Plan Review & Routing Comment Form

Project: Auburn Community Commons - Development Plan
Revision: Preliminary
Type: Development Plan
Logos ID: PROJ-PUBLIC - 2020-00000002
Due Date: **Jan 15, 2020**

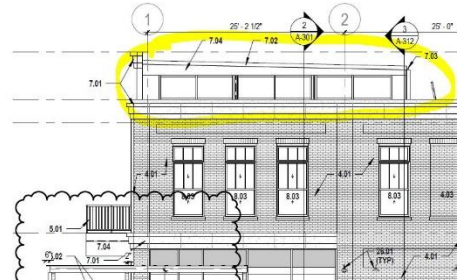
1. Security concerns with opened all day, every day
2. We'd strongly encourage incorporating some sort of storage area within the maintenance space. There always seems to be a need for secured storage areas in downtown.
3. Please consider alternatives to the roof line to allow for natural light and air:
 - Leaving the roof off the open area and designing it to be an open air plaza. It could still have the columns and trusses.
 - Similar to TQS, one portion of the roof being taller than the others with some open air vents (see image)
